Form 3160-5
(August 2007)UNITED STATES
DEPARTMENT OF THE INTERIOR
BUREAU OF LAND MANAGEMENTFORM APPROVED
OMB No. 1004-0137Expires July 3, 2010 **White Office**5. Lease Serial No.
COC3987A

1. Type of Well <input type="checkbox"/> Oil Well <input checked="" type="checkbox"/> Gas Well <input type="checkbox"/> Other		7. If Unit of C/A Agreement, Name and/or No.	
2. Name of Operator Maralex Resources, Inc.		8. Well Name and No. Trail Canyon 3-4	
3a. Address P.O. Box 338, Ignacio, CO 81137		9. API Well No. 055-T03-06204	
3b. Phone No. (include area code) 970-563-4000		10. Field and Pool or Exploratory Area Trail Canyon	
4. Location of Well (Postage, Sec., T., R., M., or Survey Description) 1927ELS; 1614 P.M., Section 3, T4S, R10W		11. County or Parish, State Rio Blanco County, CO

P&A COA's Maralex Trail

CONDITIONS OF APPROVAL FOR PERMANENT WELL ABANDONMENT/C/Rifle OfficeA COPY OF THESE CONDITIONS SHOULD BE FURNISHED YOUR
FIELD REPRESENTATIVE TO INSURE COMPLIANCE

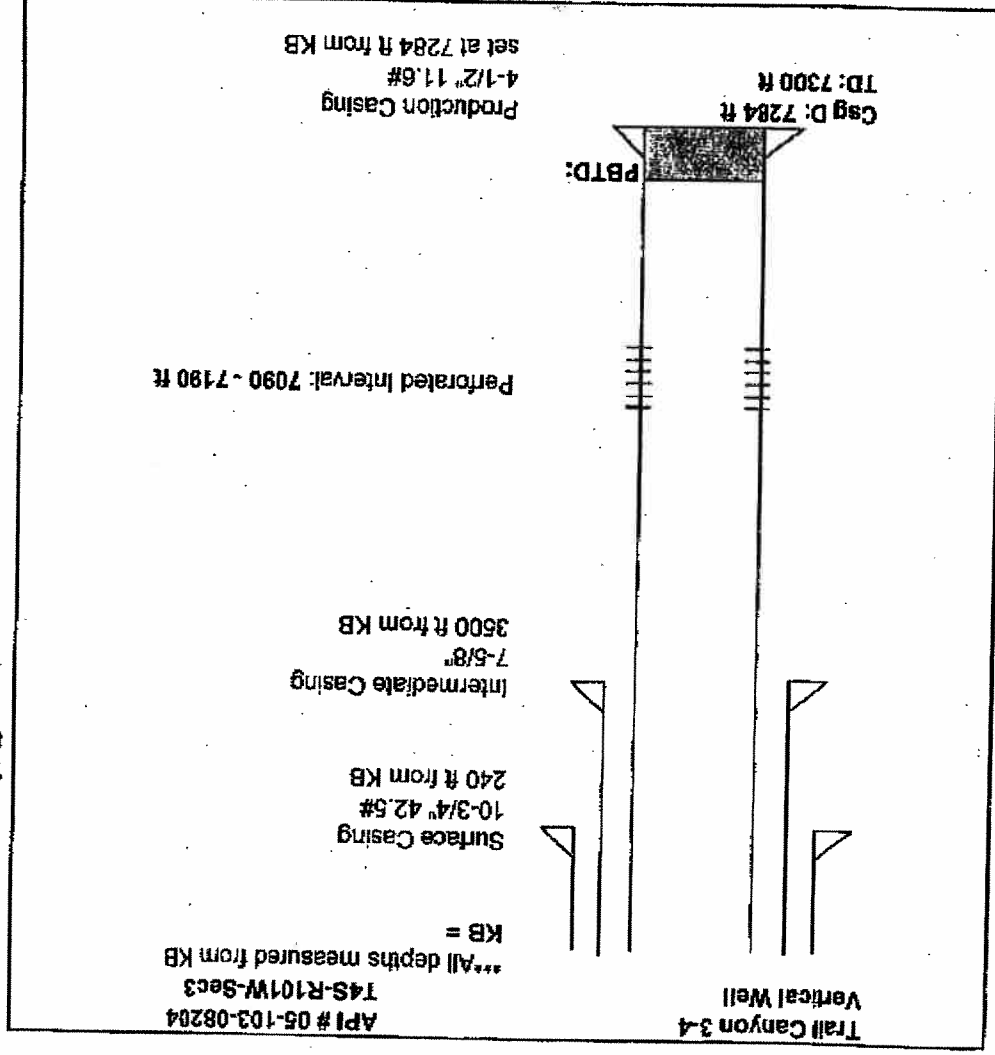
10. The procedure will be modified as follows:

Casing integrity must be proven by pressure testing.

Plugs will be tagged after an appropriate waiting period.

Per OO#2, G9. Mud. Each of the intervals between plugs shall be filled with mud of sufficient density to exert hydrostatic pressure exceeding the greatest formation pressure encountered while drilling such interval. In the absence of other information at the time plugging is approved, a minimum mud weight of 9 pounds per gallon shall be specified.

All annuli will be topped off as needed to bring cement to surface, per OO#2, G5.

The drilling plan for this well indicates an intention to set 7.625" intermediate casing at 3770'. The completion report does not mention an intermediate casing string. Maralex provided a log header which mentions an intermediate string set at 3500'. At this point, we do not know if there is an intermediate string or where the shoe is. The only way to determine this is to run an isolation scanner log to find the shoe. Once the shoe has been located, the casing will be perforated 50' below it and an attempt made to circulate to the surface. Then a cement plug will be set from 50' below to 50' above the shoe.
